MAPLE SHADE ADDITION

WICHITA, SEDGWICK COUNTY, KANSAS

RE: SUB 2000-55 -- Final Plat of Maple Shade Addition

CASE NUMBER: SUB 2000-55 -- MAPLE SHADE ADDITION

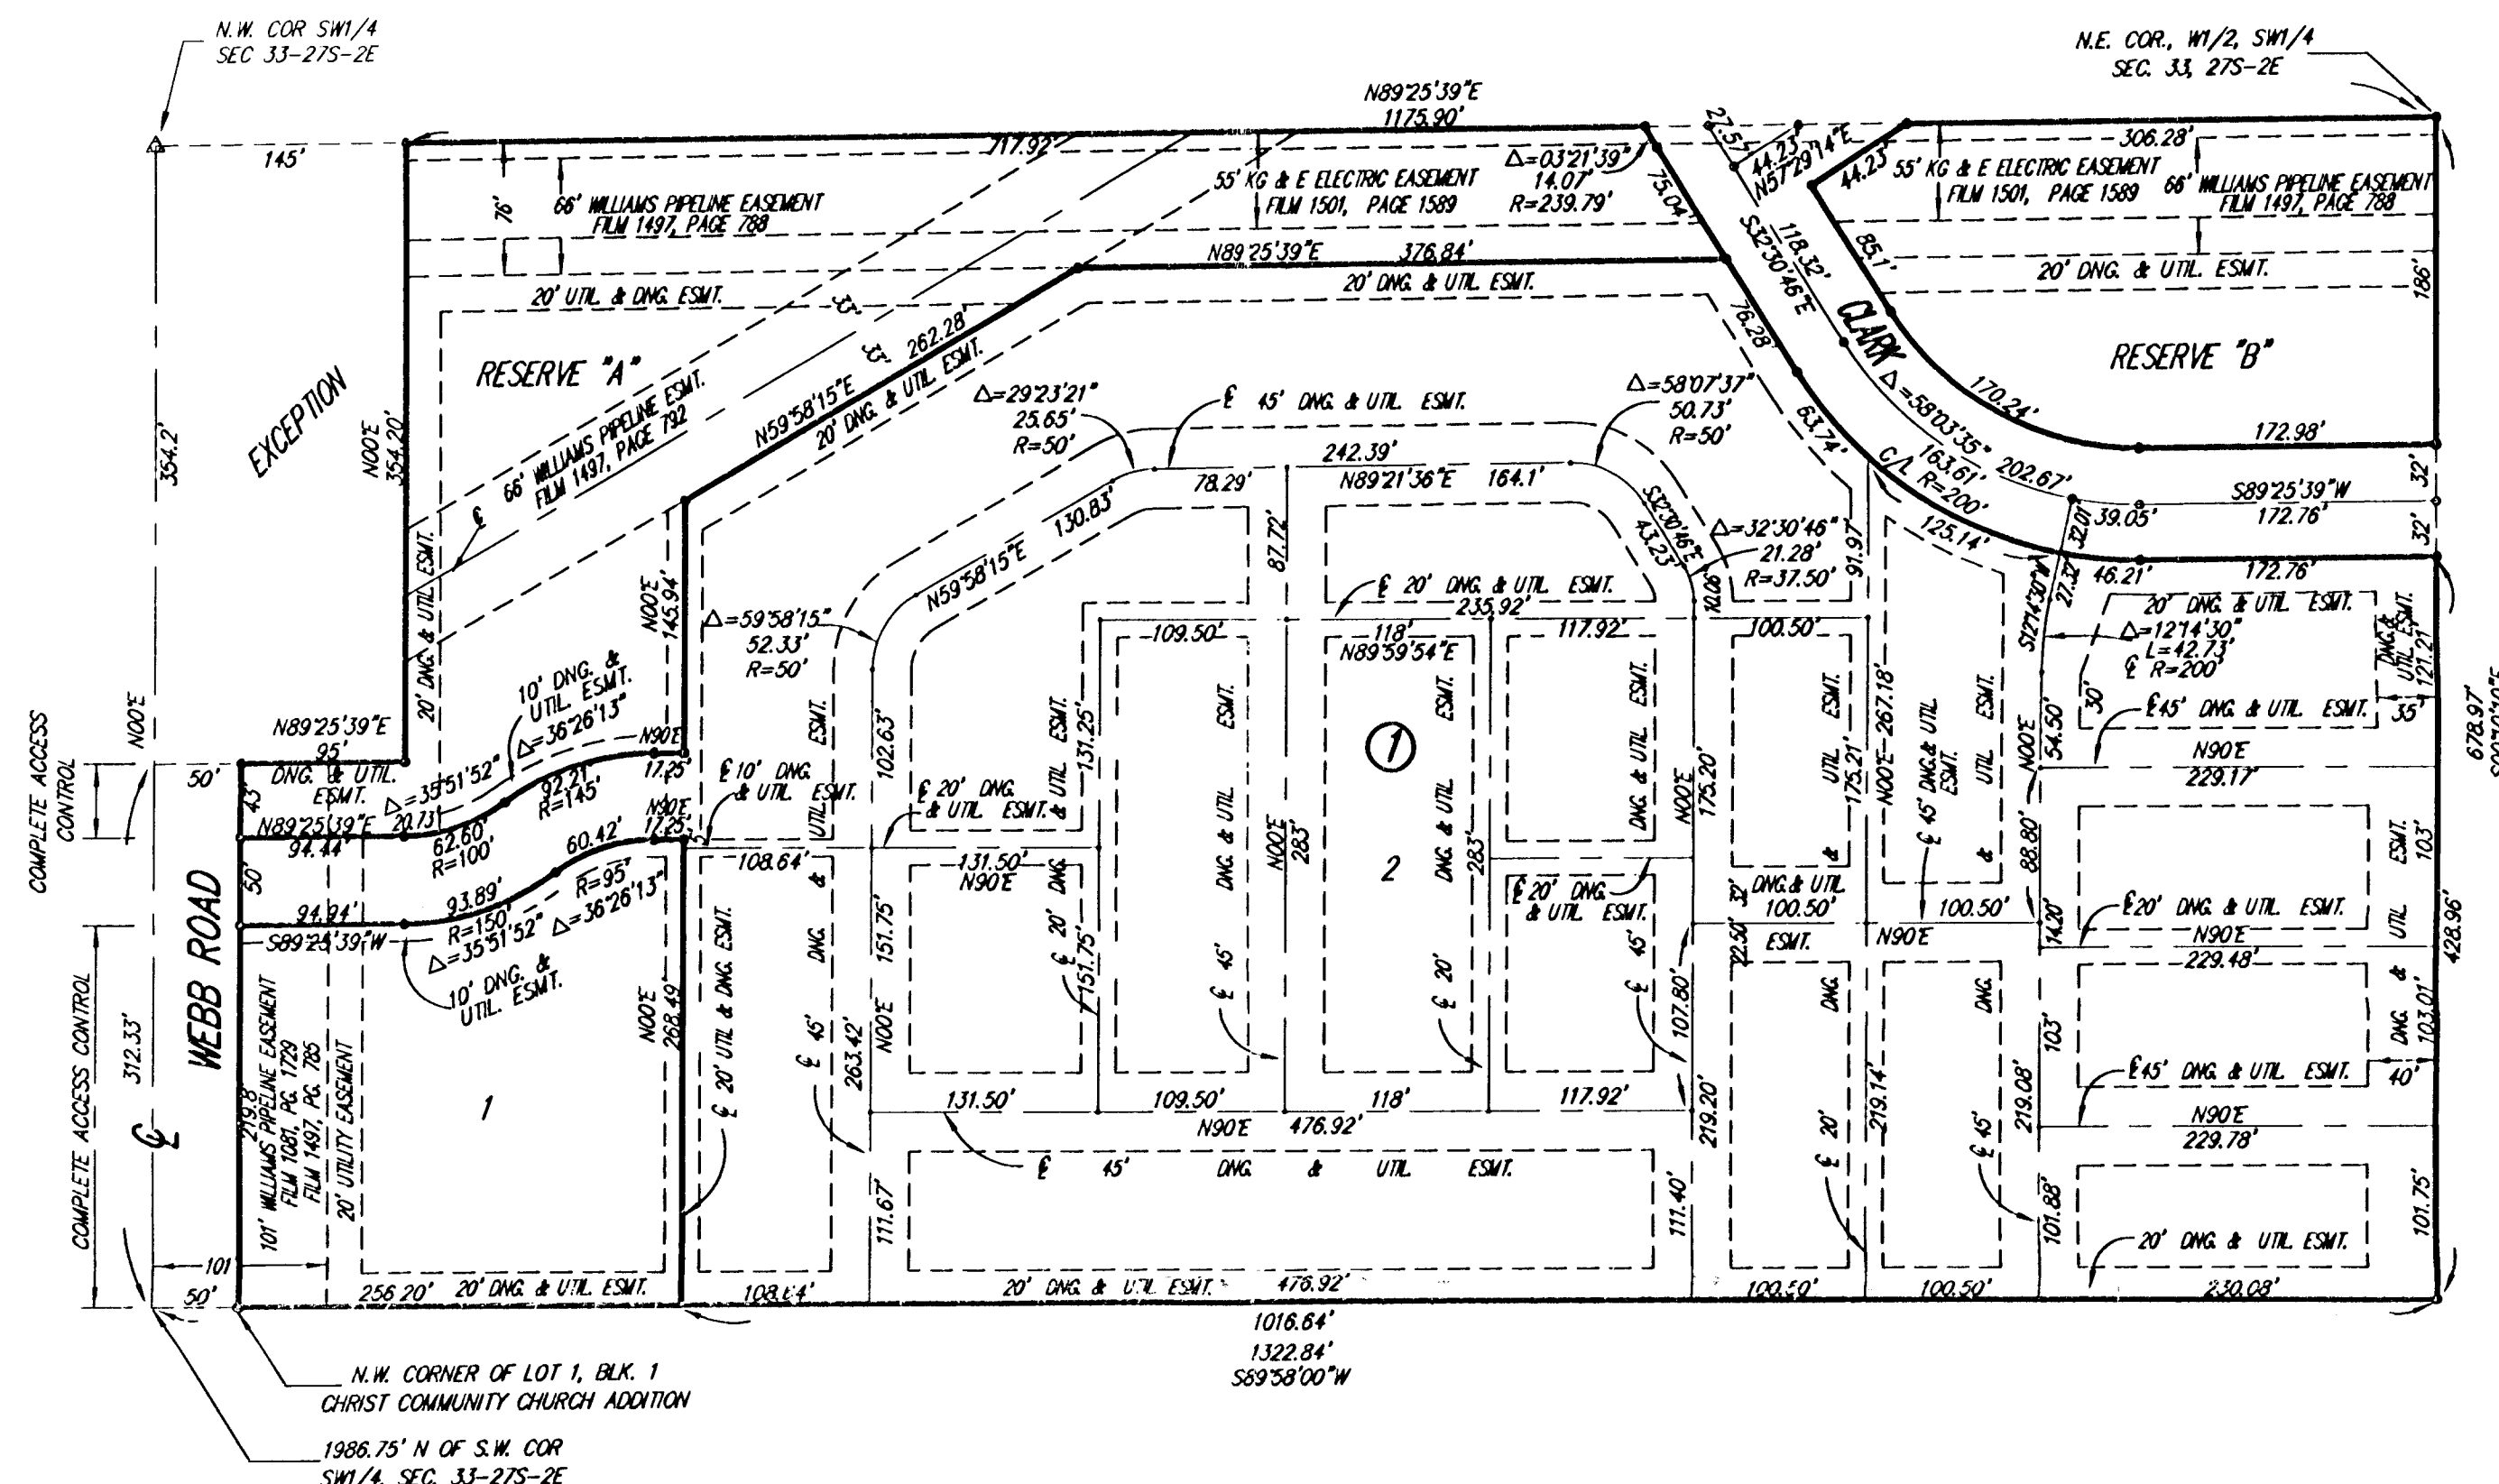
- A. As this site is adjacent to Wichita's City limits, the Applicant shall submit a request for annexation. Prior to this plat being scheduled for City Council review, annexation of the site will need to be completed.

- B. This plat will be subject to approval of the associated zone change and any related conditions of such a zone change.
- C. The applicant shall guarantee the extension of sanitary sewer to serve the lots being platted. This guarantee shall be with the City for service through the Four Mile Creek sanitary sewer system. County Engineering requests a sanitary sewer layout.

- D. The applicant shall guarantee the extension of City water to serve this site.
- E. If improvements are guaranteed by petition, a notarized certificate listing the petitions shall be submitted to the Planning Department for recording.

- F. City Engineering needs to comment on the need for any additional guarantees or easements. An off-site drainage easement is requested unless this Addition is platted concurrently with Brentwood South Addition to the east. A drainage guarantee is required.

- G. City Engineering needs to comment on the status of the applicant's drainage plan. On-site detention will be needed on the final drainage plan.
- H. The plat's text shall include ownership and maintenance responsibilities of the reserves.

- I. Provisions shall be made for ownership and maintenance of the proposed reserves. The applicant shall either form a lot owners' association prior to recording the plat or shall submit a covenant stating when the association will be formed, when the reserves will be deeded to the association and who is to own and maintain the reserves prior to the association taking over those responsibilities.

- J. For those reserves being platted for drainage purposes, the required covenant which provides for ownership and maintenance of the reserves shall grant, to the City, the authority to maintain the drainage reserves in the event the owner(s) fail to do so. The covenant shall provide for the cost of such maintenance to be charged back to the owner(s) by the governing body.

- K. For the Reserves indicated as platted for swimming pools, a site plan shall be submitted with the final plat tracing, for review and approval by the Director of Planning. The site plan shall provide the information indicated in the Subdivision Regulations. Otherwise, a conditional use and public hearing will be needed in the future.

- M. The applicant shall submit a copy of the instrument which establishes the pipeline easements on the property, which verifies that the easements shown are sufficient and that utilities may be located adjacent to and within the easements.

- N. The applicant's agent shall determine any setback requirements for the pipelines by researching the text of the pipeline agreements. If a setback from the pipeline easements is provided for in the pipeline easement agreements, it shall be indicated on the face of the plat.

- O. The Applicant shall guarantee the paving of the proposed streets. The guarantee shall also provide for sidewalks on the south side of Clark.
- P. The paving guarantee shall include the installation of a temporary turnaround at the terminus of Clark at the plat's east line unless the abutting street to the east has been constructed. The temporary turnaround shall be established by separate instrument.

- Q. City Fire Department should comment on the plat's street names. Stoneybrook should be revised to "Clark".

The street name has been revised as requested.
- R. A Protective Overlay Certificate shall be submitted to MAPD prior to City Council consideration, identifying the approved Protective Overlay (referenced as P-O #83) and its special conditions for development on this property.
- S. The plat's text shall include language that a drainage plan has been developed for the plat and that all drainage easements, rights-of-way, or reserves shall remain at established grades or as modified with the approval of the applicable City or County Engineer, and unobstructed to allow for the conveyance of stormwater.
